Dear Mrs. Moseley,
re: Planning Application No: WSCC/083/13/KD

Proposal: The installation of a well and associated infrastructure, including access road and soil bunds, for the drilling of a vertical borehole and contingent horizontal borehole from the same well for the exploration, testing and evaluation of hydrocarbons for a temporary period of three years.

**T2083 - Celtique Energie Traffic Data
Review, Kirdford Road, Wisborough
Green, West Sussex**

Initial Review of Traffic Data and Highway Measures

Figure 3.2 – ‘Crashmap’ Database

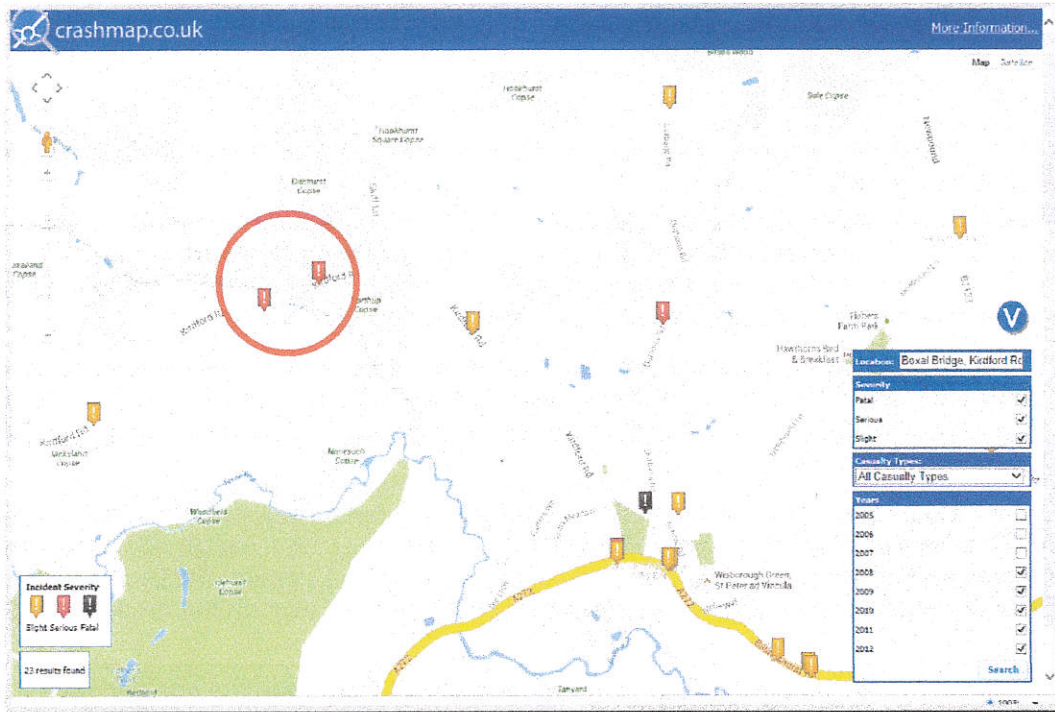
Normal industry practice requires a 5 years period to be assessed for the purposes of a Transport Assessment, and as such, the occurrence of collisions is not currently at a level, which in our opinion would require mitigation due to the proposed development. Please see the extract from the “Crashmap” database below.

Figure 3.3 - Freely Available 'Crashmap' Database

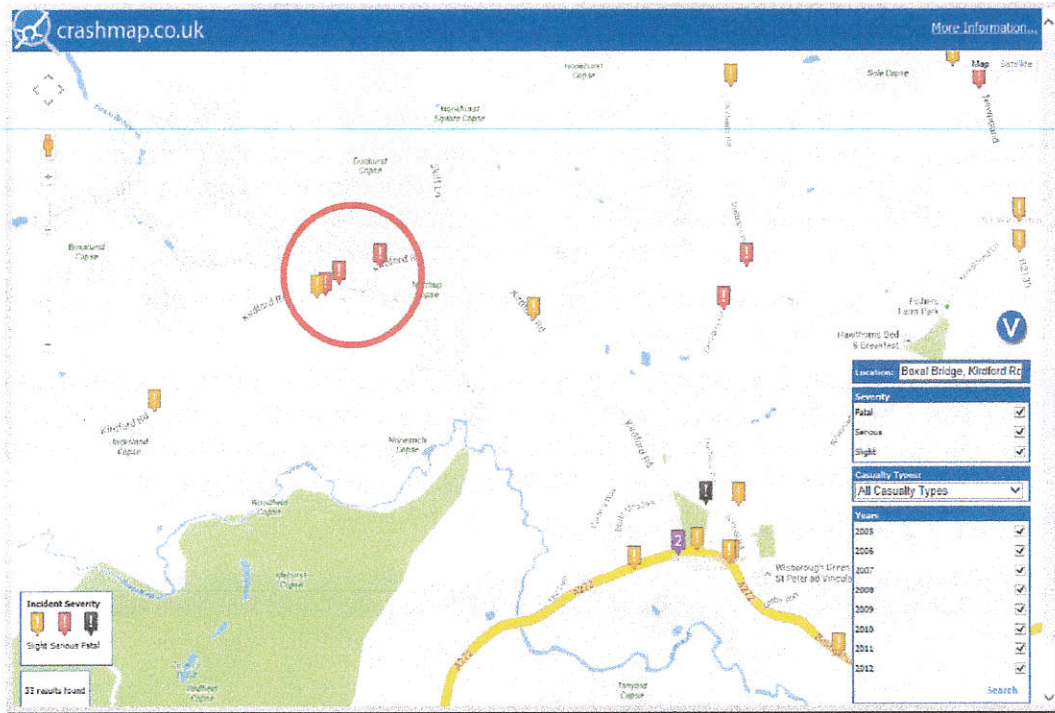
However, if the period is extended beyond the normal 5 year assessment period, to 2005, (please see below) a different scenario occurs, where the section of road immediately adjacent to the site has had a number of slight and serious collisions.

This is significant, as there appears to be a cluster in comparison to the remainder of Kirdford Road. This would indicate that this location may be problematic in road safety terms, especially for any increase of turning movements coming out of the proposed

entrance on to a road that has reduced visibility, even with an actual typical speed currently between 40 mph and 50 mph.
